## **ARC** REGIONAL REVIEW NOTICE

ARC REVIEW CODE: R1607081

Name of Proposal: Brookhaven-Oglethorpe MARTA Station TOD Review Type: DRI Submitting Local Government: City of Brookhaven Date Opened: July 8, 2016 Deadline for Comments: July 25, 2016 Date to Close: July 28, 2016 (If no significant issues are identified during the comment period, the review will close on July 25, 2016 per LCI Expedited Review process in ARC DRI Rules)

BROOKHAVEN/OGLETHORPE UNIVERSITY STATION TOD PROJECT Brookhaven, Georgia 120 DRI #2604

ZONING SITE PLAN

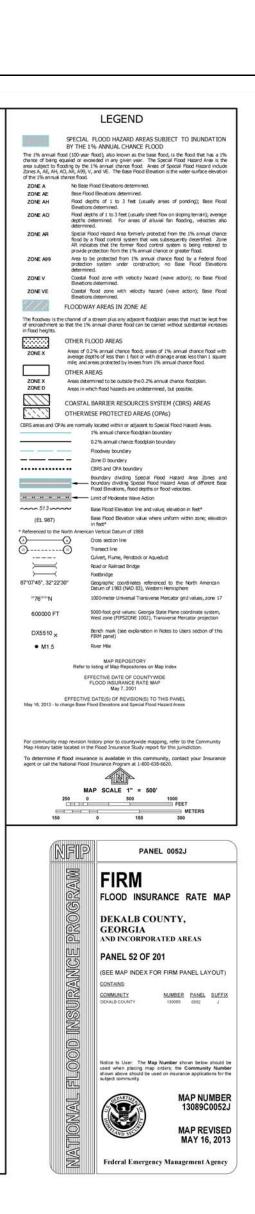
The current plan proposes a total of 2,096 parking spaces - 1,536 for the DRI itself and 560 dedicated for MARTA users. ARC recognizes that the DRI spaces are required by City code and the MARTA spaces represent significantly less dedicated MARTA parking than exists today. However, in keeping with the goals of ARC's LCI program, and considering the site's direct rail transit access, MARTA, its development partners and the City should collaboratively explore reducing the amount of parking on site. This effort would reinforce and encourage the use of alternative transportation modes, especially transit, given its direct connection to this DRI. Use of these modes is already present in the area, and parking reductions can be accomplished, at least in part, through shared parking strategies. In terms parking placement, much of the parking appears to be screened from view to minimize visual impact.

- The parking provided is excessive for a transit station area and a mixed-use development, where shared parking among uses is feasible and approximately 20% of the units are senior housing. Providing 2,096 parking spaces will induce more traffic. This is important given the community's concerns about traffic. Recommend reducing the overall number of parking spaces, identifying shared parking options by time of day or building use, and TDM strategies such as valet, ridehailing service areas, secure bike parking, etc.
